Industry and Sutphen Changes

Industry and Sutphen Changes Outline

NFPA Changed from 1901 to 1900

Electronic Stability Control (ESC) - continued

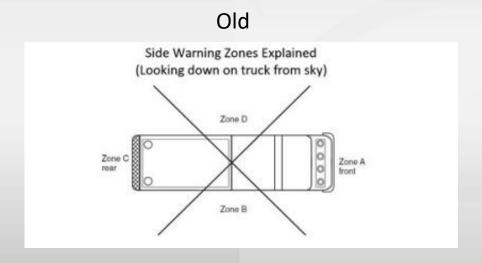
- 7.14.3 Rollover Stability.
- **7.14.3.1** Structural fire apparatus not equipped with a stability control system and all wildland fire apparatus shall meet either of the following:
 - (1)* The apparatus shall remain stable in both directions in accordance with Table 7.14.3.1 when tested on a tilt table in accordance with SAE J2180, A Tilt Table Procedure for Measuring the Static Rollover Threshold for Heavy Trucks.
 - (2) The calculated or measured vertical center of gravity (VCG) divided by the rear axle track width shall not exceed the applicable criterion in Table 7.14.3.1.
- **Table 7.14.3.1** Rollover Stability Requirements

- 7.14.3.2 Certification shall be by one of the following methods:
 - (1) Performing a tilt-table test on the completed apparatus
 - (2) Calculating the point at which the apparatus will tip based on centers of gravity, suspension geometry, suspension compliance, and tire compliance
 - (3) Comparing the apparatus design to a previously certified substantially similar apparatus
 - (4) Demonstrating that the calculated or measured center of gravity (CG) divided by the rear axle track width does not exceed the value in Table 7.14.3.1

Cummins Exhaust Canister – Stacked Design

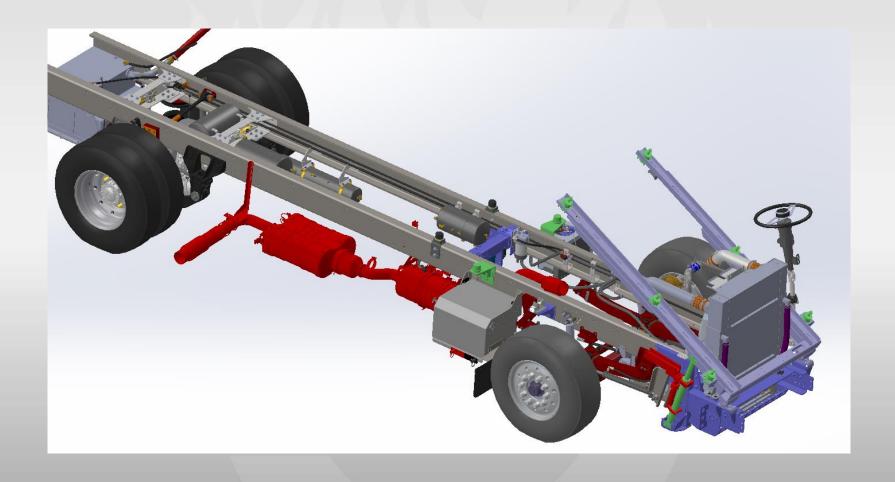
- Original 2 canister design all got shoved into a single canister, and is not going back to a dual canister design, but bigger.
- New design is based on new Federal guidelines for startup to increase heat with an updated heater.
- Canister location for SPH is still to be determined. Various locations available are the entire R1 or under the turntable and having to redesign the belly bars.
- Delete aux heater. Back in the day they would circulate hot water out of the pumper and run it to the engine to cool the pump. Refer to this as your appendix. With today's technology of new pump designs and engine designs this is no longer required.

X15 Engine Hood

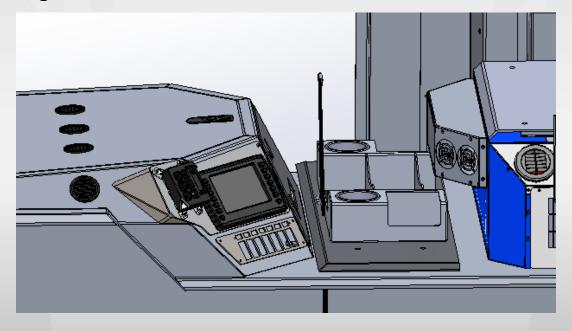
• What if there was an option to not have the lower command console extension with a X15 engine?

• Chassis engineering is also looking at designs to incorporate this with the new X10 engines as well so that Sutphen will be able to offer one consistence engine hood design for all Cummins engine offerings moving forward.

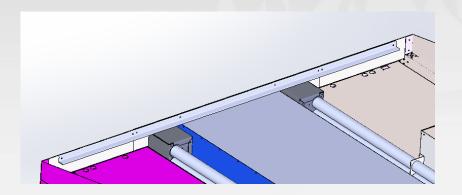
- Isolated components to show above for clearer idea of how each component goes together.
- Split the floor and fender into 2 pieces to create a more serviceable compartment.
- Split the wall from 1 piece to 2 pieces for improved alignment from the vendor.

- We split the rear treadplate into 3 components to help with disassembling the entire end of the truck to replace the components.
- We are adding an angle across the bottom of the treadplate to help support the end from deforming due to flex.
- This will allow us to keep the A1 in position while replacing components on either compartment.
